Marulan South Quarry

Submissions Report

Boral Resources (NSW) Pty Ltd

December 2006

Figure 1
Habitat Management Area
Marulan South Quarry

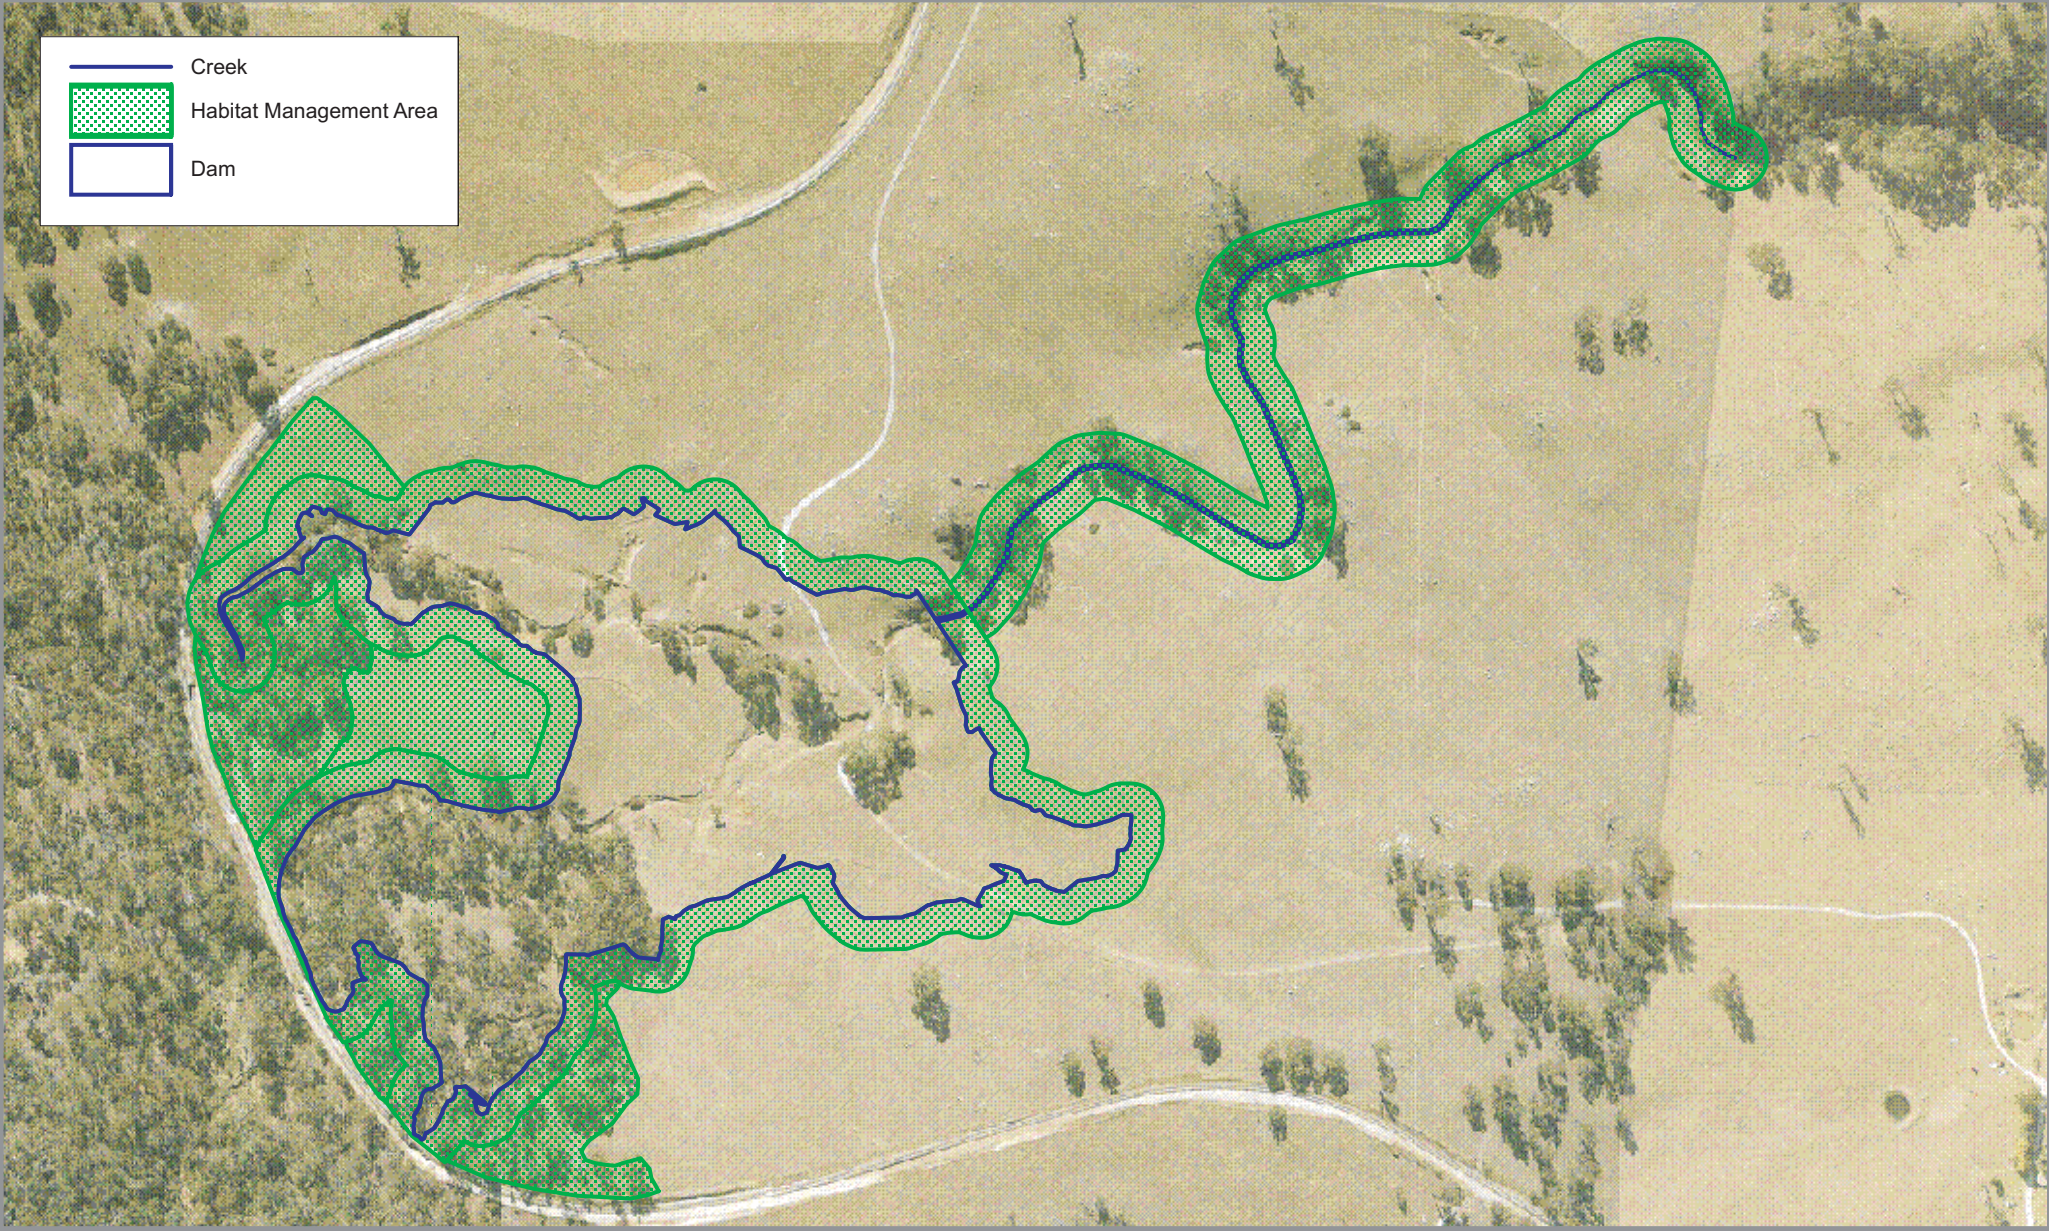
<i>Threatened species and their habitat</i>	- Considers the loss of 2.6ha of Box-Gum woodland EEC significant in the local context given the generally poor condition of the remaining EEC in the region 2.6ha of EEC at Dam 1 site should be retained and subject to improved management strategies, or - Offset area should be at least 26ha (10:1 offset ratio) and should improve management of existing EEC rather than replanting of cleared paddocks. Necessary replanting should be at dam margins and along Tangarang Cr line and should include the EECs shrub and ground layer as well as tree species
<i>Aboriginal Heritage Assessment</i>	- Concern that the assessment was not undertaken in accordance with the draft "Guidelines for Aboriginal Cultural heritage Impact Assessment and Community Consultation" and as such DEC disagrees that there is no known ethnohistorical or post contact history relevant to the proposal - Management strategy to be included for the discovery of unanticipated Aboriginal objects of significance - DEC has not received site recording forms for the November 2005 and March 2006 surveys as legally required

A Habitat Management Area is also proposed to be established around the Tangarang Creek corridor to enhance the habitat value of the creek.

A Habitat Management Area will be established around the area of Box-Gum Woodland to be retained and around the periphery of Dam No. 1 and Tangarang Creek to enhance and protect the area from development for the life of the quarry as shown on *Figure 1*. The Habitat Management Area will be protected from future quarrying and will include active management of the Box-Gum Woodland to be retained and the establishment of new areas of Box-Gum Woodland. The boundaries shown are indicative only and are subject to change following survey and design.

Note: The boundaries shown are indicative only and are subject to change following survey and design.
